SERVICE BULLETIN

No. 515

Piper Aircraft Corporation

Subject: Control Cable Ball Joint Retainer Installation

TYPICAL BALL JOINT RETAINER INSTALLATION

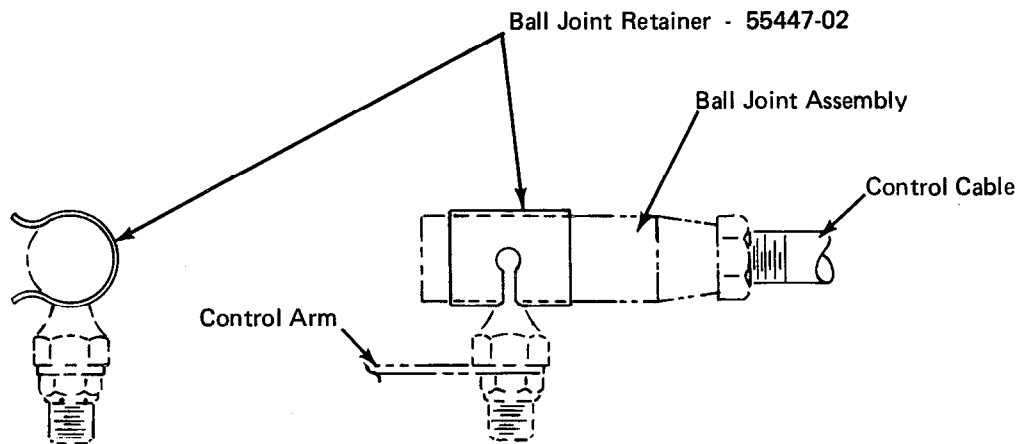
Purpose: There have been a few reports received from the field describing inadvertent detachment of the engine controls (i.e., throttle, prop governor and/or mixture) at the control cable ball joint attachment assembly. Failure of this ball joint assembly renders the particular control system inoperative. Although these ball joint attachment assemblies are subject to routine inspection, per published Piper inspection data, excessive wear - over a prolonged period of operation - in conjunction with inadequate inspection of this area - can permit detachment of the ball joint "ball" from its mating socket.

This service release announces availability of a safety device (retainer) that, when installed on the ball joint assembly, prevents disengagement of the ball from the socket (attached sketch/instruction sheet illustrates a typical ball joint assembly retainer installation).

1. Install ball joint retainer 55447-02, as shown above, to the control cable ball joint assemblies located in the engine compartment. See list below for appropriate model, control cable and quantity per airplane.

2. Install ball joint retainer 55447-02, as shown above, to the control cable ball joint assemblies located in the engine compartment and cockpit fuel control panel for the PA-31T. See list below for control cable and quantity.
